NC DEPARTMENT OF  
**HEALTH AND  
HUMAN SERVICES**

April 11, 2025

RE: Technical Assistance - Tarheel Army Missile Plant Site Evaluation of Potential Surface, Groundwater, Soil Contamination and Vapor Intrusion (VI).

Figure 1. Monitoring well VOC measurements obtained from selected sites within the TAMP.

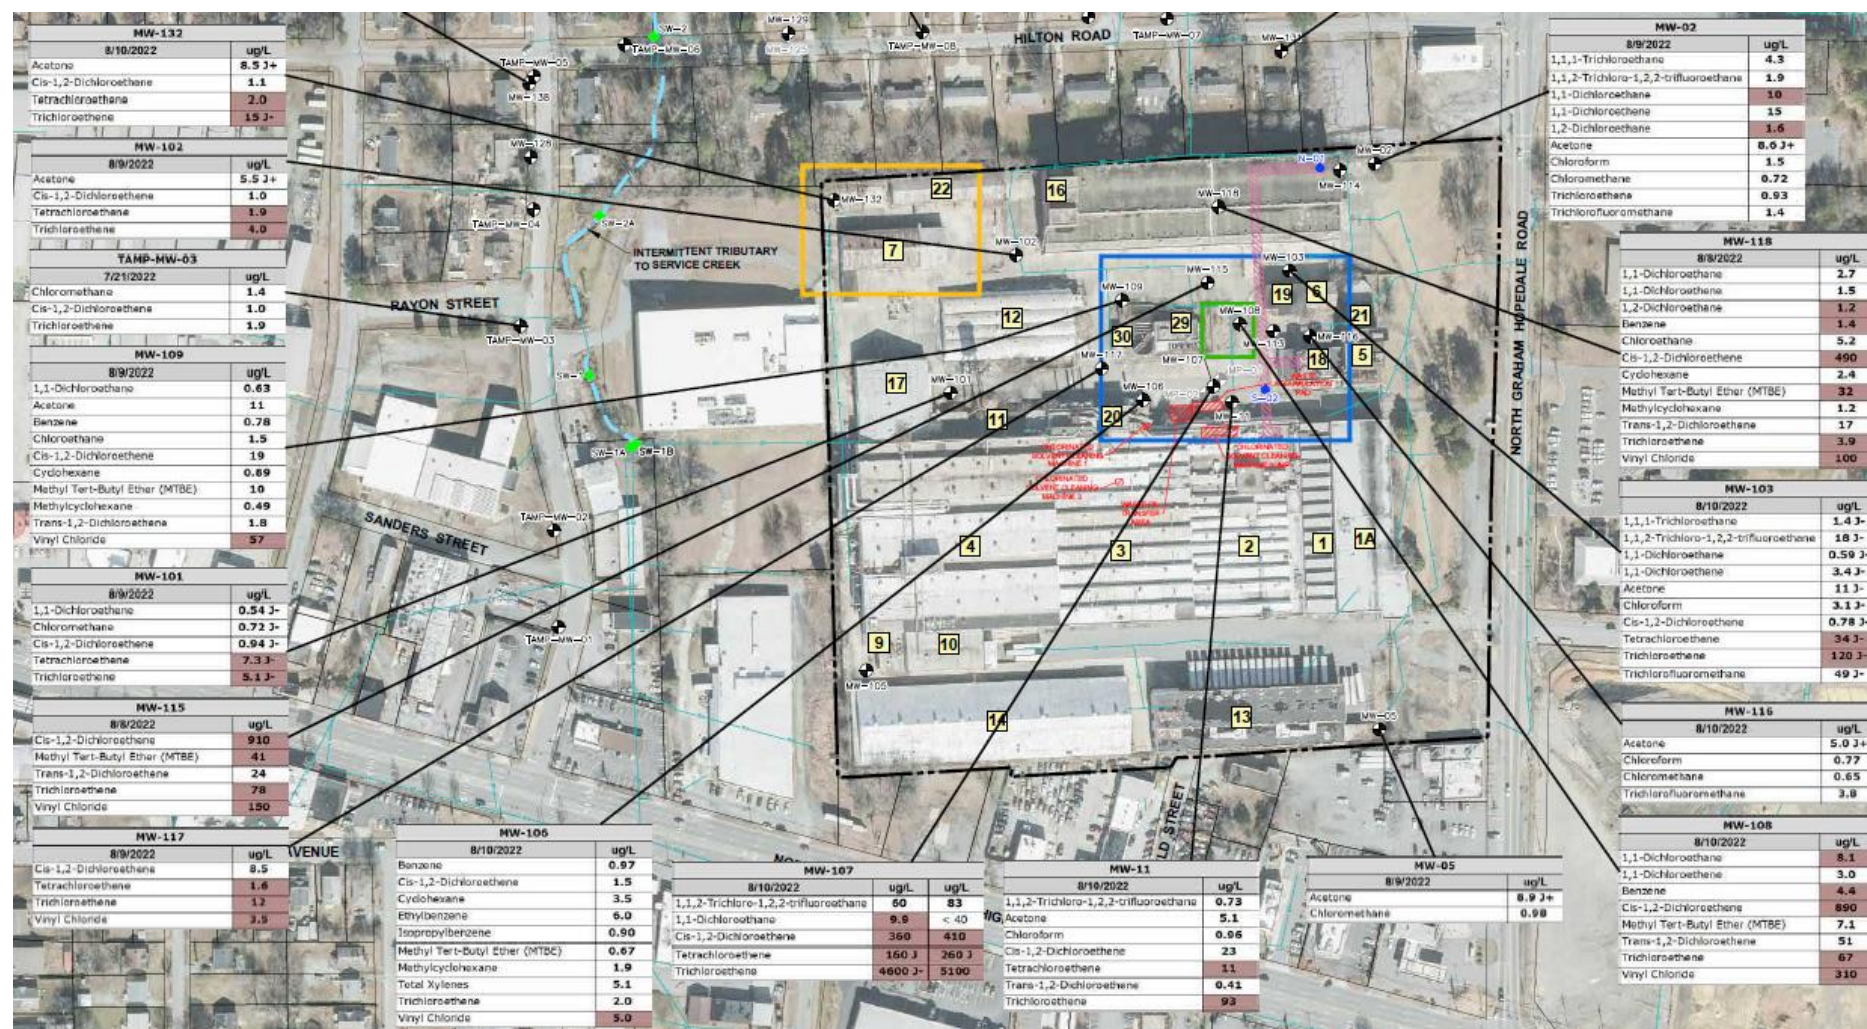
2. **Ongoing Site Contamination.** The report<sup>3</sup> made it clear that the TAMP site itself contains heavily contaminated water beneath the facility. This is best depicted in **Appendix A, Figure 1**. Monitoring wells from multiple sites within the TAMP site shows a wide range of VOCs present over a wide range of concentrations. These VOCs include 1,2 dichlorethene, MTBE, trichloroethene and vinyl chloride, among others, many of which exceed the NC 2L standards. Other VOCs are also present, including known carcinogens (benzene as one example), that may or may not, depending on the MW location, exceed a 2L standard<sup>17</sup>.

2. Ongoing Site Contamination. Numerous data sets confirm that the TAMP site is clearly contaminated with several volatile organic compounds (VOCs) including, but not limited to, TCE, benzene, 1,1-dichloroethene, tetrachloroethene and 1,4-dioxane. Per- and polyfluoroalkyl substances (PFAS) were also reported in ground water and soil. **HACE recommends that a comprehensive site remediation plan be developed that addresses the cleanup and disposal of contaminated soil, water and other contaminated material on the site itself, with special consideration given to the secondary public health effects to the public, such as aerosolization of contaminated soil and dust, that cleanup efforts may contribute to downgradient contamination outside of the physical boundaries of the TAMP facility.**

**Figure 2.** Representative VOC data collected from the Intermittent Tributary to Service Creek surface water source. Green indicates the exceedance of the NC 2B water standard.

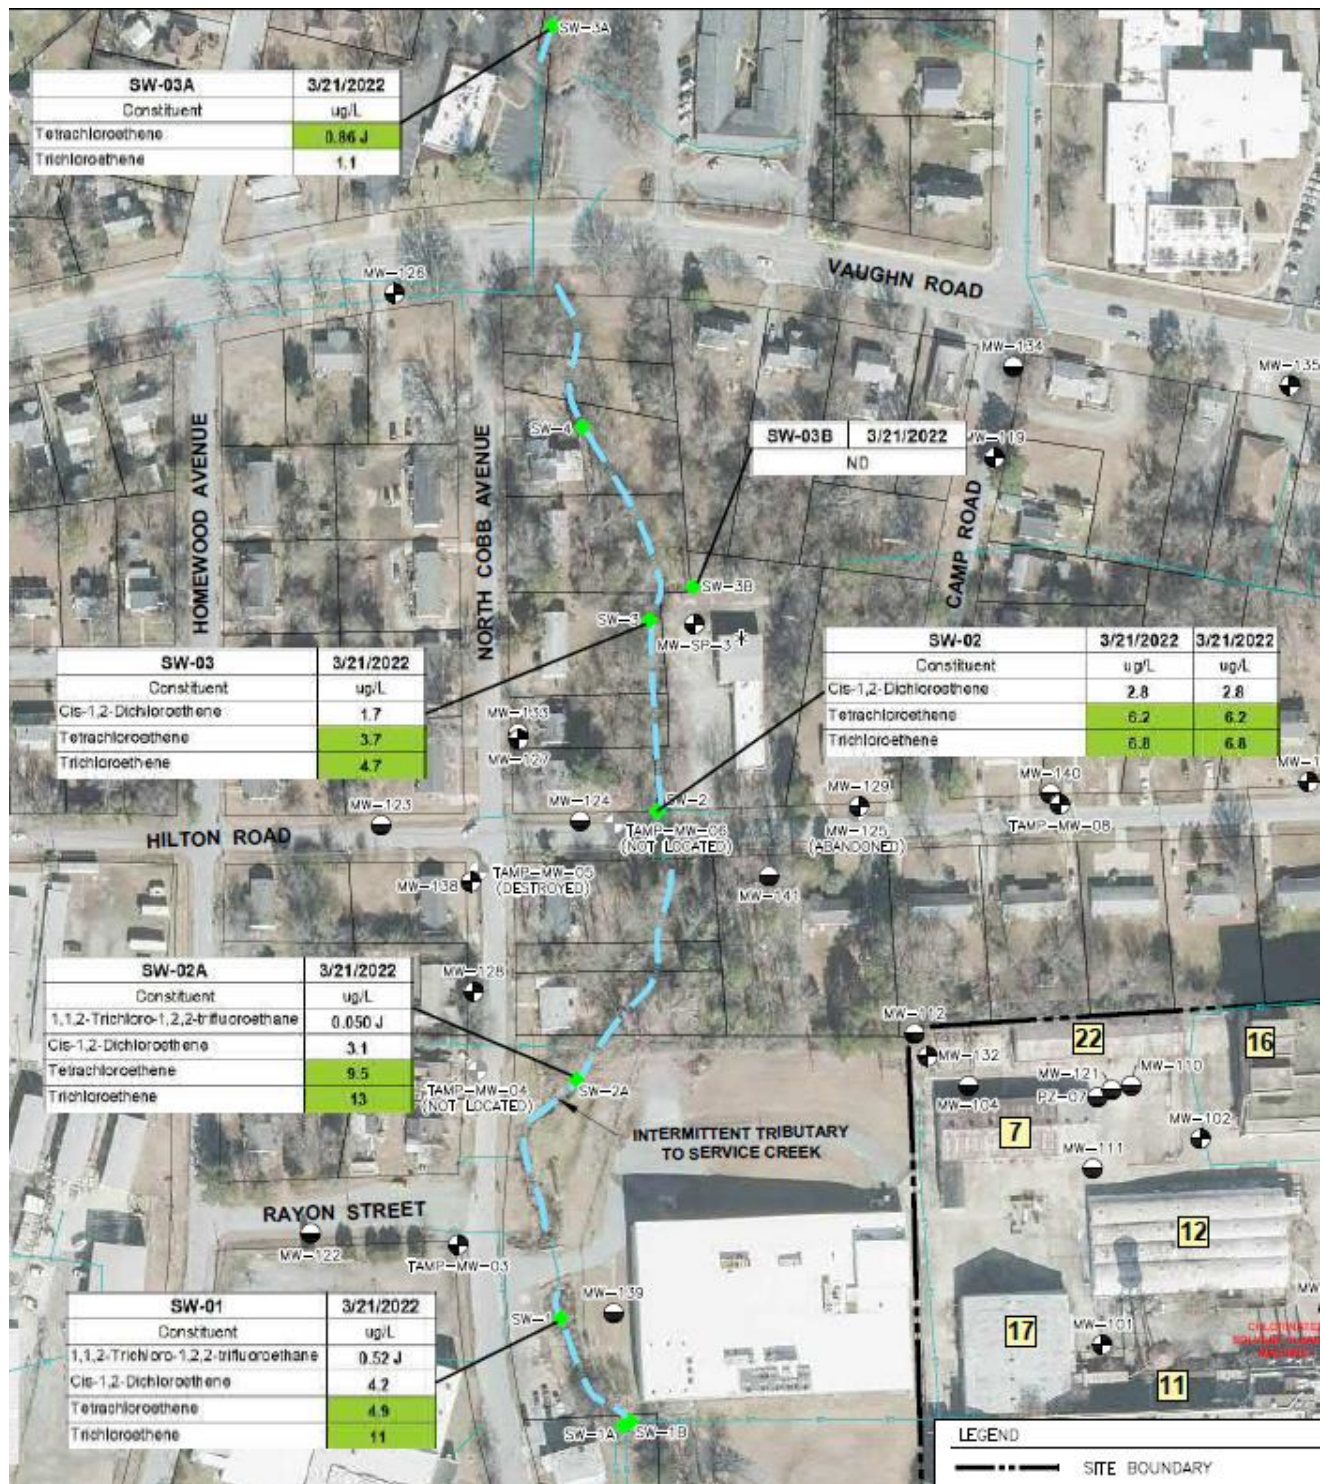
3. **Offsite Surface Water Contamination.** The report<sup>3</sup> noted that there was one body of surface water, labeled as “Intermittent Tributary to Service Creek” that runs roughly north and south and is located to the west of the TAMP site. This creek had water samples collected and tested for VOCs at time points in the spring, summer and fall of 2022. The report showed the data results from all three timepoints; although the numbers differed somewhat between the time of collection, the results indicate that surface water is contaminated with VOCs. An aerial photo is shown in **Appendix A Figure 2** as representative data for all the time points that were tested and shows this creek relative (shown as a dotted teal line) to the TAMP site (shown in a dotted black line).

Specifically, this creek was found to contain surface water VOCs during all three seasons of the year, generally highest at the SW-02A collection point, in particular tetrachloroethene and trichloroethene, concentrations of which exceed the 2B water standard, shown in green. The concentrations of VOC tend to decrease in the surface water samples to the north and south of SW-02A but are still present. The report noted that the topography of the land from the western side of the site slopes down from the TAMP site and that groundwater tends to run in both northern and western directions from the TAMP site. The topographic features coupled with the VOC data collected from this creek support the conclusion that surface water runoff from the contaminated TAMP site and/or groundwater moving from the TAMP site are likely sources of the VOC contamination in the creek and reasonably increase the likelihood of potential VI issues on properties near the surface water source with a potential public health impact.

3. Offsite Surface Water Contamination. Data collected shows that downgradient surface water impacts from VOCs and PFAS chemicals have exceeded the NCAC 02B.0202 Water Quality Standards for Surface Waters (2B Standards)<sup>17</sup> and the USEPA Nationally Recommended Water Quality Criteria for Aquatic Life and Human Health.<sup>18</sup> VOCs and other contaminants have likely been moving off site via the northwest surface water for years<sup>16</sup>. This is likely due to either surface water/stormwater runoff from the site and/or movement of contaminated groundwater from the site to nearby downgradient surface water. **HACE recommends that a comprehensive remediation plan be developed that addresses the removal of the source of contaminated soil and other materials contributing to downgradient surface water contamination.**

**Figure 5.** Graphical representation of Passive Soil Gas (PSG) sampler placement (yellow triangles) in relation to the TAMP site northern boundary (dotted black line).

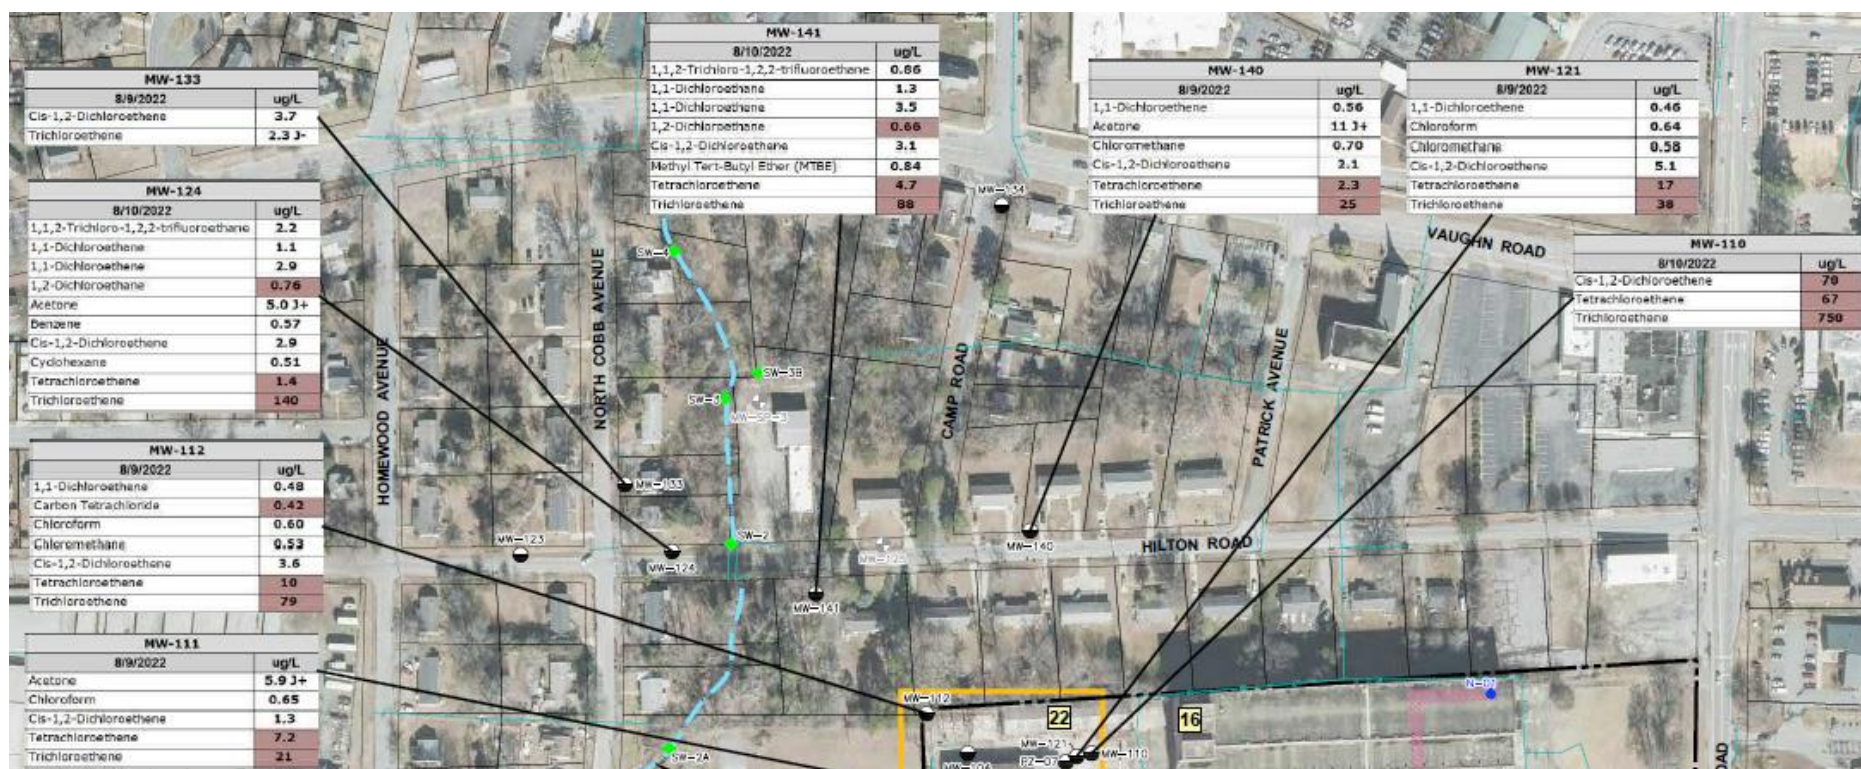
5. **Offsite Soil Vapor (Soil Gas).** The report<sup>3</sup> contained data that attempted to discuss chemical vapors exiting the soil into the air above the soil surface. Briefly, the reports stated that passive Beacon soil gas samplers were placed adjacent to building foundations at five off-site properties to evaluate the potential for VI into the buildings from the off-site VOC groundwater plume. The passive soil gas samplers were used to accommodate shallow drilling refusal in the sample locations and the potential for the shallow groundwater to intrude into traditional soil gas points that would need to be set deeper. The property addresses and uses were at 219/221 N. Cobb Ave (residential), 301 N. Cobb Ave (residential), 1612 Hilton Road (commercial), 1615/1617 Hilton Road (residential) and 1707/1709 Hilton Road (residential).

Toluene and Total Petroleum Hydrocarbons (TPH) in the C10-C15 chain link length was reported on PSG-1 and PSG-5, respectively. The data suggests that there is little if any VOCs being emitted from the soil at the sample collection points. However, PSGs were not placed further north and west of TAMP facility where residential houses are located, and no samplers were placed in proximity to the Lucent Technologies facility where a plume is thought to exist. In addition, the report noted that if future VI samples are to be collected, summa canisters (in lieu of passive Beacon samplers) be used. This recommendation was based on greater data quality by summa canisters analyzed by Method TO-15, as compared to Beacon samplers analyzed by USEPA Method 8260C. It was also noted that data from the PSGs reported in 2020 saw a greater number of constituents during the soil-gas sampling events in August 2017, February 2019, and April 2019, as compared to the limited number of constituents (i.e., only toluene and TPH C10-C15) detected in July 2022 using Beacon samplers. It was also noted that passive samplers may not be favored according to the North Carolina guidance<sup>13</sup>, which states that passive samplers may be used when shallow soil contamination or groundwater is present at less than 5 feet bls and are "limited to field screening only during the investigation of the VI." In summary, the placement and type of the samplers used in the report were likely not sufficient to determine the risk of VI in residences north and east of the TAMP site.

**Figure 6.** Schematic of the northern and central areas of the TAMP facility showing water samples from On-Site Tunnel.

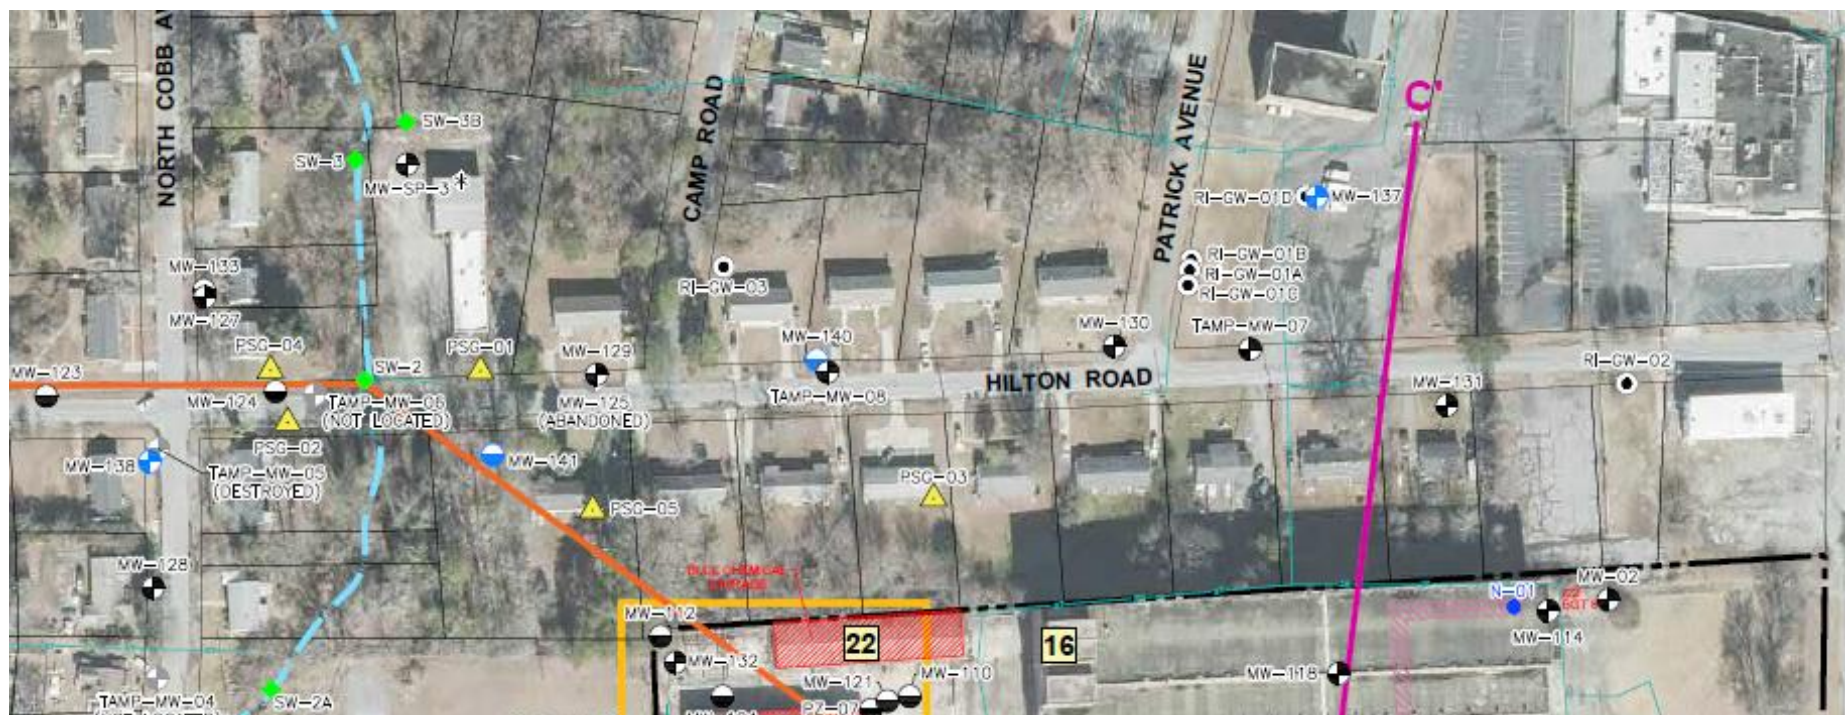
6. **Known and Unknown Subsurface Structures Contamination.** This section pertains to structures beneath the TAMP site itself but excludes surface and groundwater contamination, as discussed above. **Appendix A Figure 6** shows a schematic of the northern and central areas of the TAMP facility. The area highlighted in yellow with red lines on the right side of the figure depicts a roughly “L” shaped underground tunnel beneath the surface of the TAMP site. The report<sup>3</sup> indicates that the tunnel still exists and has standing water on the floor of the tunnel. Water samples were obtained and analyzed for chemical analysis. The results are shown in **Appendix B Table 4**.

NC DEQ VI Guidance.<sup>13</sup> states that all preferential pathways (utility and sewer beds, stormwater structures, and other unknown links offsite) should be evaluated. As shown in **Appendix B Table 4**, two sites containing free standing water in the tunnel (one on the north side and one on the south side) were sampled (labeled N-01 and S-02) with several VOCs detected. Tetrachloroethene and trichloroethene exceeded the 2B surface water and wetland standards. Air samples in the tunnels were not reported as sampled or reported.

5. Comprehensive Delineation of Nature and Extent of Known and Unknown Subsurface Structures and Preferential Pathways On and Offsite. The known underground tunnel on the TAMP site is potentially contaminated with VOCs (and likely PFAS chemicals) because of contaminated ground water migrating through contaminated soil and water above or adjacent to the one known underground tunnel on the site. **HACE recommends that this known tunnel be remediated, and the surrounding soil and groundwater be remediated as part of a comprehensive site remediation plan.**

**Figure 7.** Aerial view of Huffman Field / Fairchild Field in Burlington, NC, circa 1950.

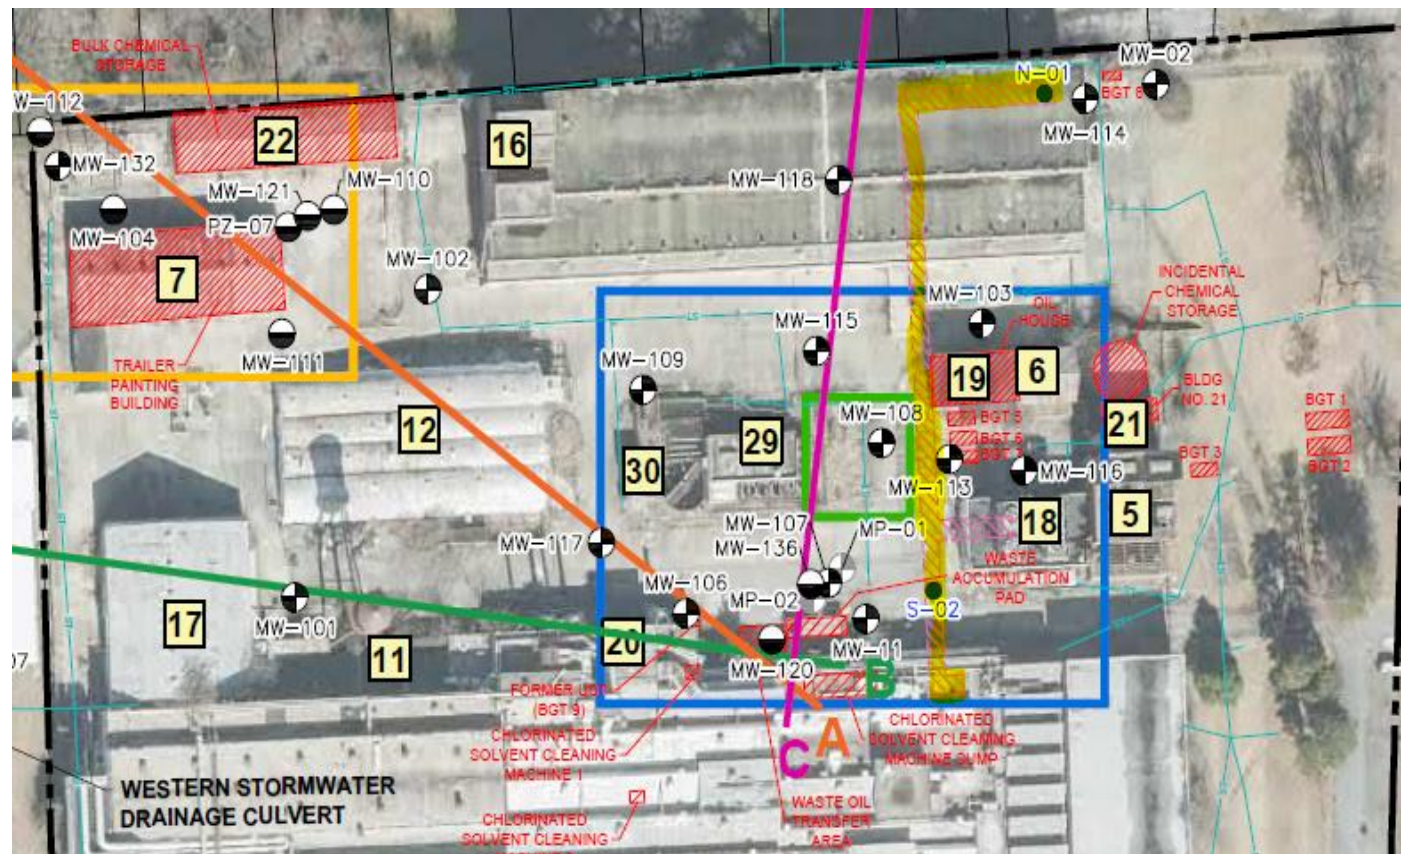
Historical records indicate an airstrip near the TAMP facility did exist. What remains of this airstrip is not easily identified today using Google Maps. However, publicly accessible websites have some useful information regarding what was likely the Huffman Field/Fairchild Field in Burlington, NC<sup>7,8</sup>. Figure 7 shows what this airfield looked like circa 11/18/1950 on a USGS aerial view. The photo depicts Fairchild Field as having a single paved northeast/southwest runway, with a ramp & some small buildings on the northeast side, and the former Fairchild aircraft factory (now known as the TAMP site) across the street to the northwest (upper left portion of the photograph) from the airfield. It is possible that an underground tunnel existed or still exists and that was likely used to move equipment and/or personnel from the TAMP site to the airfield in a secure manner and not having to interfere with the flow of traffic to access either site. This area now appears to have several businesses built over where this airstrip used to be located. The potential public health impact of these tunnels and/or the chemical contents of this tunnel is unknown.

**HACE also recommends that further investigations be conducted to conclusively determine if a second and longer tunnel that runs north to south from the TAMP site to properties to the south of the TAMP site exists today.** This investigation should also include other possible preferential pathways including sewer lines, underground utilities, etc. If a tunnel or other preferential pathways exist, their specific location needs to be identified; and the contents in and around them should be analyzed to determine if further investigation of offsite contamination to the south of the TAMP site and if a public health impact is present. The public health impacts of VI in homes and businesses to the south of the TAMP site cannot be known until the second tunnel and other preferential pathways, if they exist, are better characterized.
